Log # TXX-89577
File # 10010
908.3
Ref. # 10CFR50.34(b)

SUBJECT: COMANCHE PEAK STEAM ELECTRIC STATION (CPSES)
DOCKET NOS. 50-445 AND 50-446
ADVANCE FSAR SUBMITTAL
UPGRADE AND ADDITION OF CLASS 1E ELECTRICAL
EQUIPMENT IN THE PRIMARY PLANT VENTILATION
SYSTEM TO MAINTAIN NEGATIVE PRESSURE

Advance FSAR Change Regarding the Upgrade and Addition
of Class 1E Electrical Equipment in the
Primary Plant Ventilation System
to Maintain Negative Pressure

FIG. 8.3-11 SHEET 3

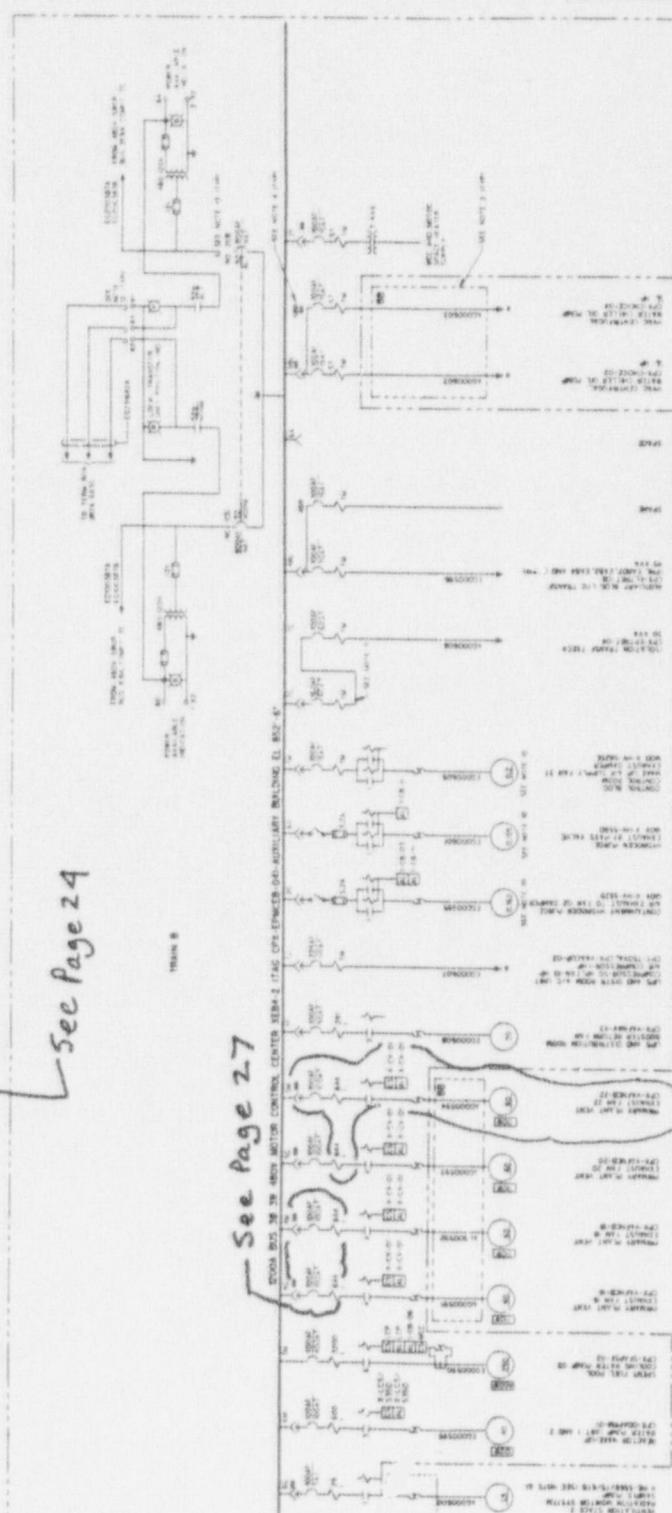
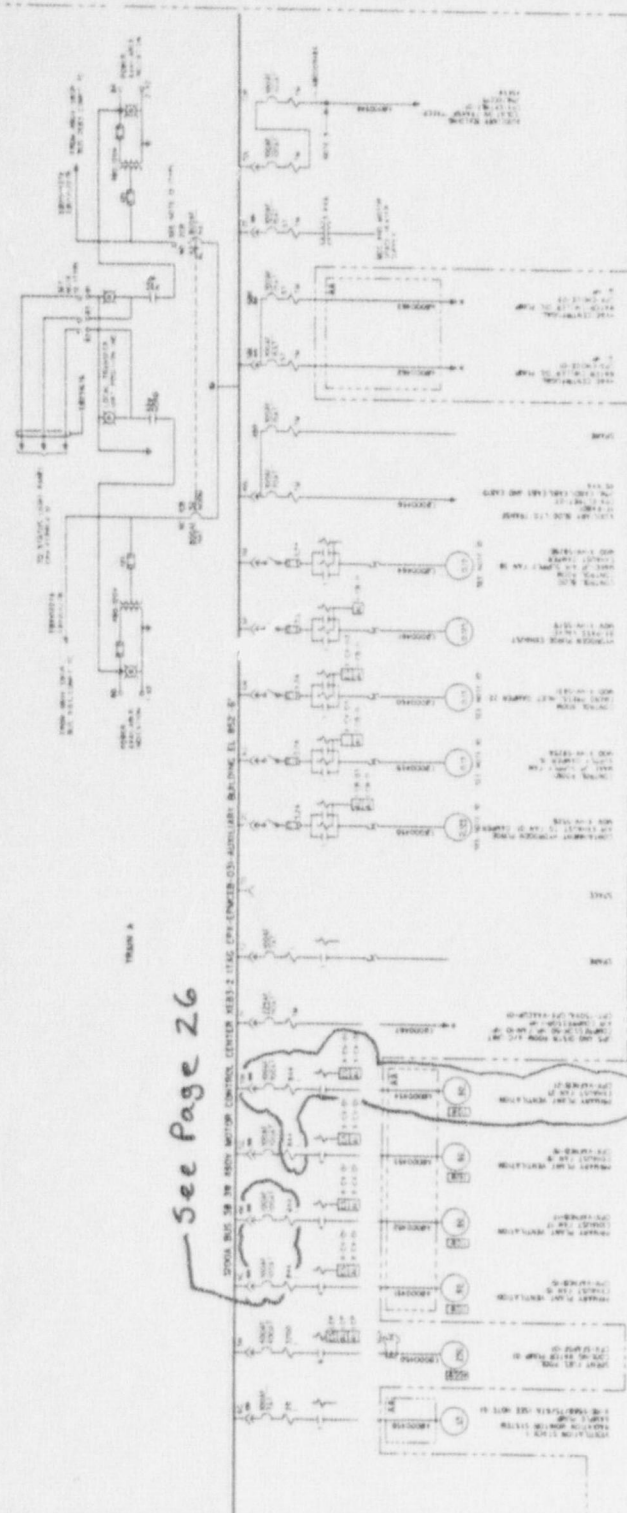
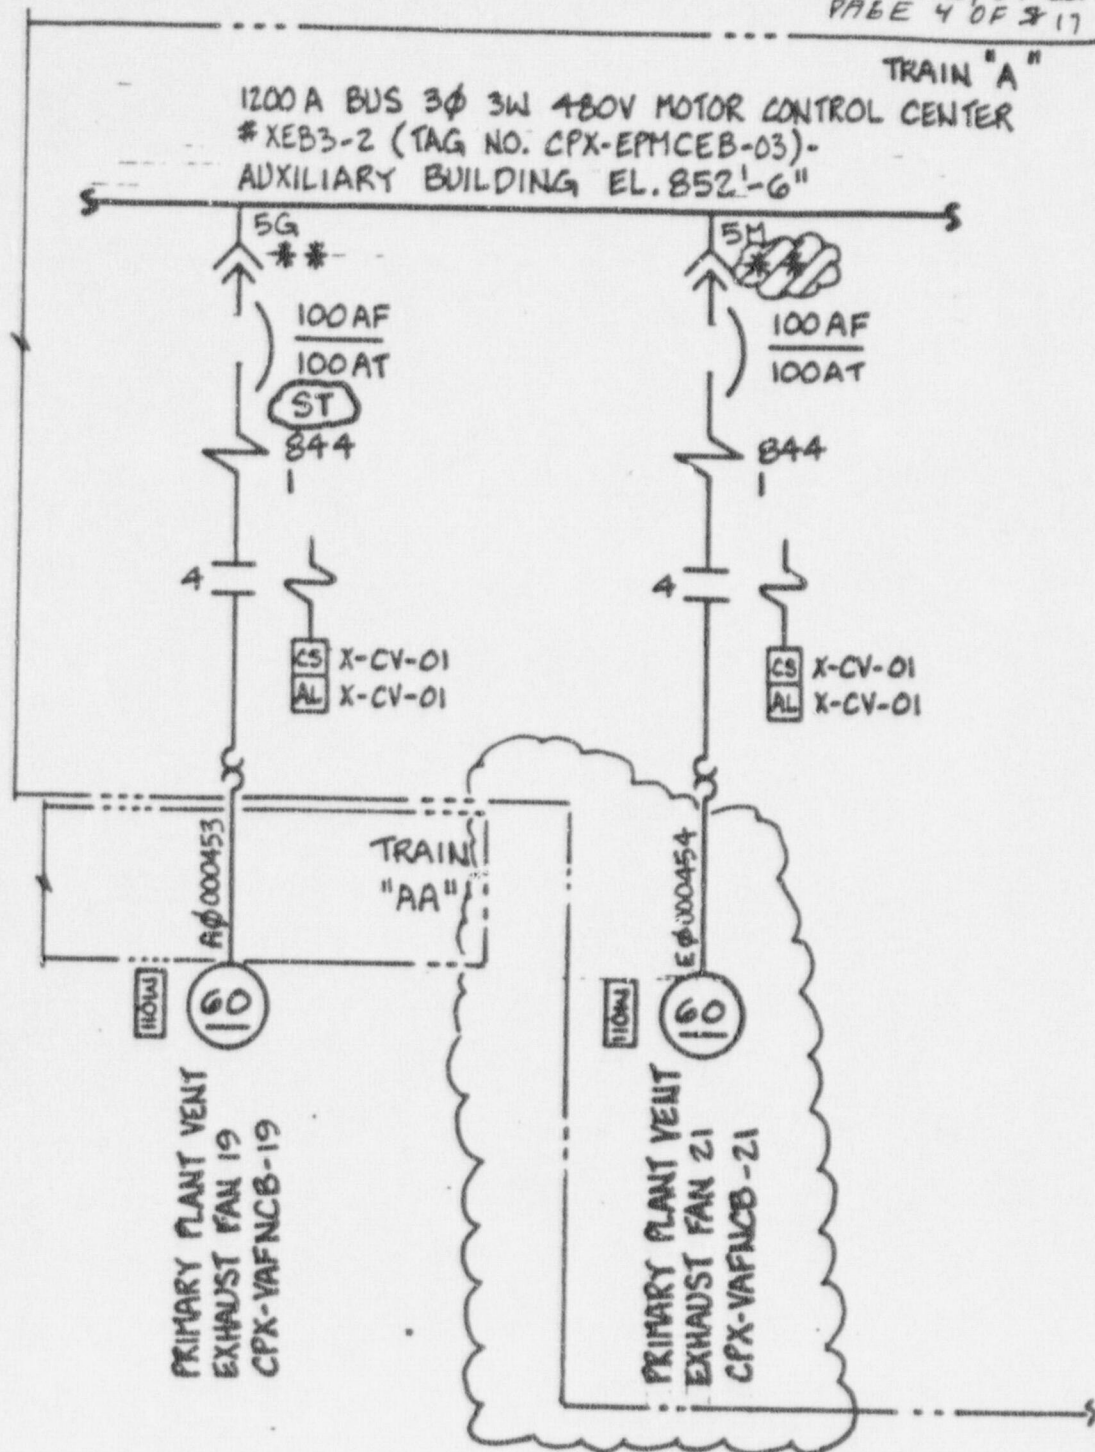
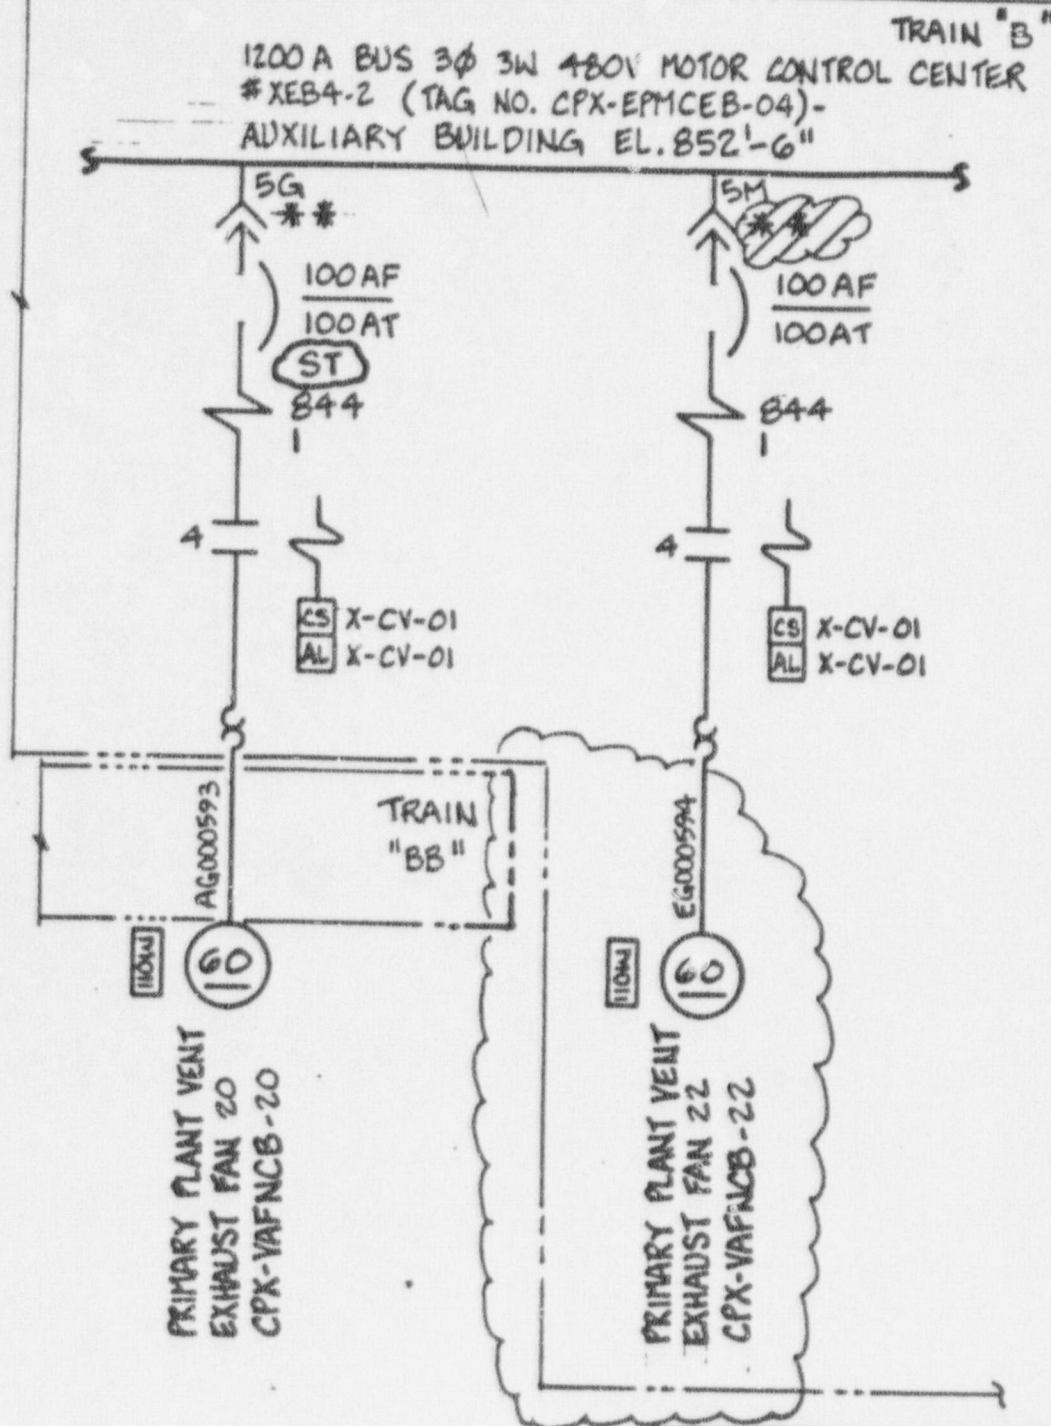
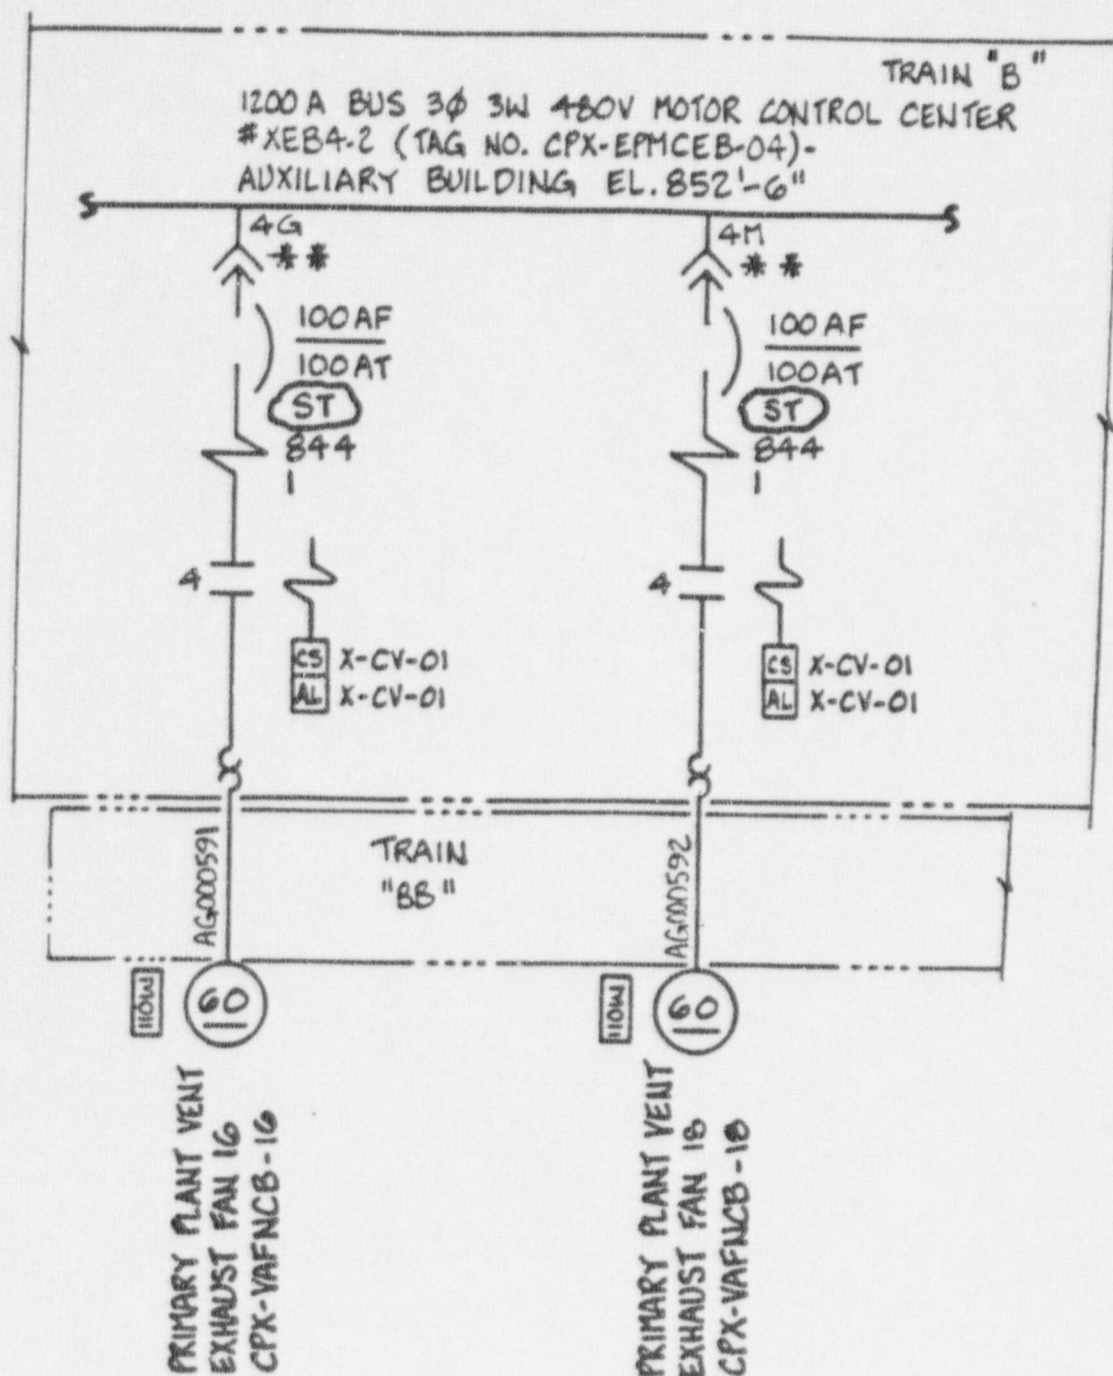
- 2 See Sheet No(s):3
Upgrades two Primary Plant Ventilation Exhaust Fans (CPX-VAFNCB-21, 22) and their power cables to Class 1E

in Compartment 5M of 480V MCC XEB3-2 and Compartment 5M of 480V MCC XEB4-2, respectively. Also, removes the "S" signal trip from each Exhaust Fan's circuitry.

Adds "S" signal trip to the breakers associated with each of the following Primary Plant Ventilation Exhaust Fans (CPX-VAFNCB-15, 17 & 19) in Compartments 4G, 4M & 5G for 480V MCC XEB3-2, respectively.

Adds "S" signal trip to the breakers associated with each of the following Primary Plant Ventilation Exhaust Fans (CPX-VAFNCB-16, 18 & 20) in Compartments 4G, 4M & 5G for 480V MCC XEB4-2, respectively.
